Exhibition of Concept Redevelopment Application for Ivanhoe Estate, Macquarie Park - SSD 8707

Attachment 1 – Office of Environment and Heritage (OEH) comments - Ivanhoe Estate Concept Redevelopment SSD 8707

Figure 1 – Concept Development footprint and impact on STIF

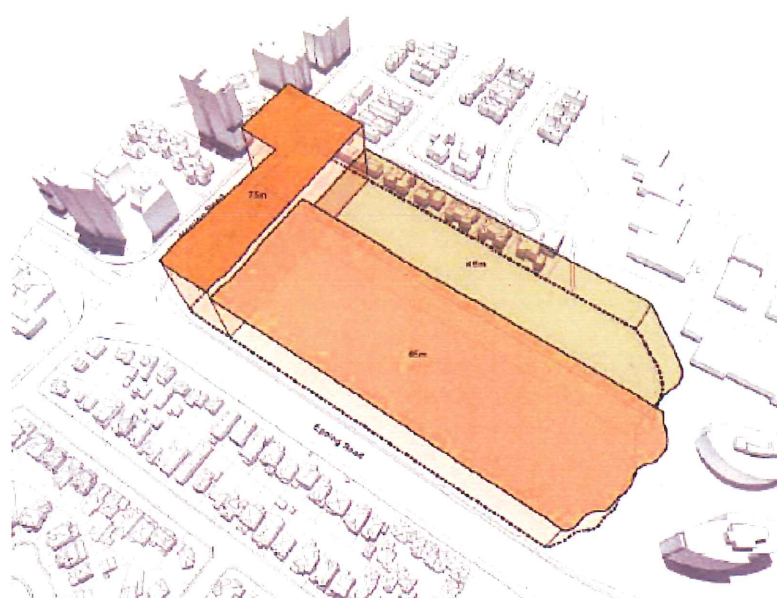
- retention of the existing threatened ecological community and adjoining vegetation community along Epping Road, which would require modifying the proposed construction footprint and development layout and
- that the deficiencies in the BAR as described in Appendix 1 are addressed.

- Principle 1 of the NSW Biodiversity Offsets Policy for Major Projects states that *"Before offsets are considered, impacts must first be avoided and unavoidable impacts minimised through mitigation measures. Only then should offsets be considered for the remaining impacts."* It is considered that the proposed development fails to avoid direct impacts on threatened ecological communities. It is not considered that adequate planning/siting of the proposal has been carried out as per the Framework for Biodiversity Assessment (FBA). Specifically, the FBA requires proponents to identify and avoid direct impacts to threatened ecological communities (TECs). An alternative footprint design could avoid impacting on the EEC particularly the STIF EEC primarily located along the perimeter of the sites southern boundary. There is opportunity to reduce the building footprint than currently shown in Figure 1 below and this could be achieved with higher building forms, with increased buffers and setbacks to this EEC or relocation of development.

Figure 2 – Proposed Concept Development Height

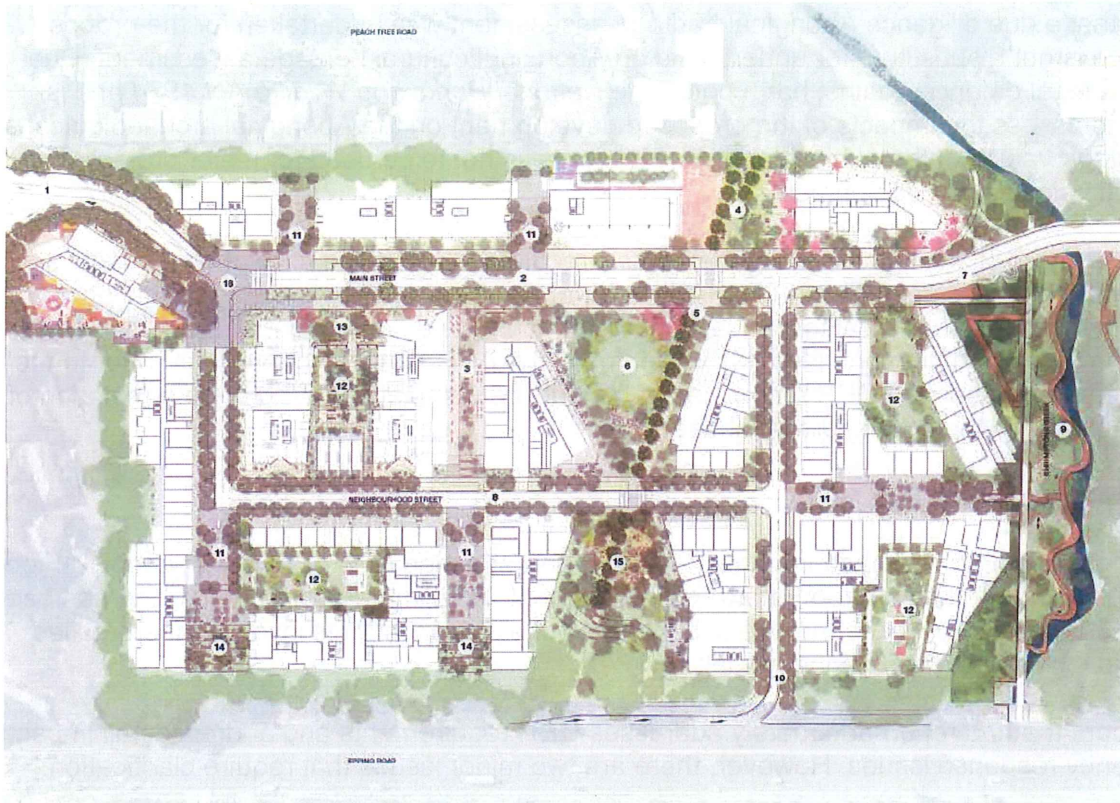
OEH suggests the development footprint could be reduced and higher building heights could be proposed to preserve more STIF. It is noted that a 65m height control (equivalent to 21 storeys based on 3m floor to ceiling heights) is proposed along the southern boundary to Epping Road, refer to Figure 2 below. The consultant's report does not assess what the impact is on the vegetation remaining from overshadowing and limited light especially vegetation along Epping Road where a 65m height is proposed and where good quality STIF is located. The proponent should calculate the reduction in the conservation value of the remaining patch of vegetation not just the areas that are removed.

Figure 3 Public Domain Plan

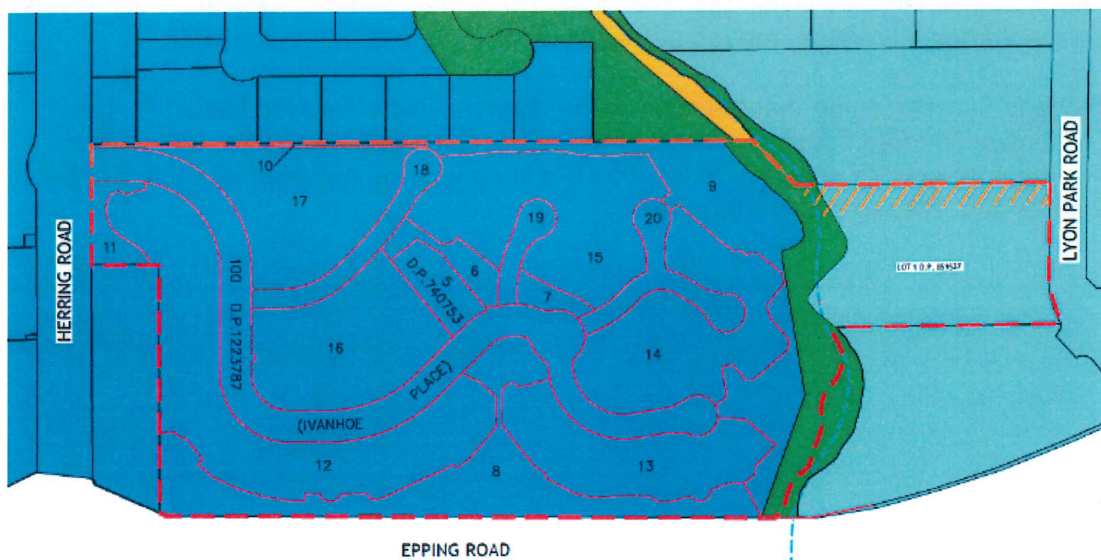
- The proposal introduces the concept of a hierarchy of public spaces such as Forest to neighbourhood and the public domain plan shows areas earmarked as Forest thresholds with stepped terraces (identified as item 14 on the public domain plan Figure 3 below). The proposal should aim to minimise landform alteration in the forest areas and preserve existing trees and it is unclear whether the stepped terraces are proposed or are a natural element of the Forest landscape area.
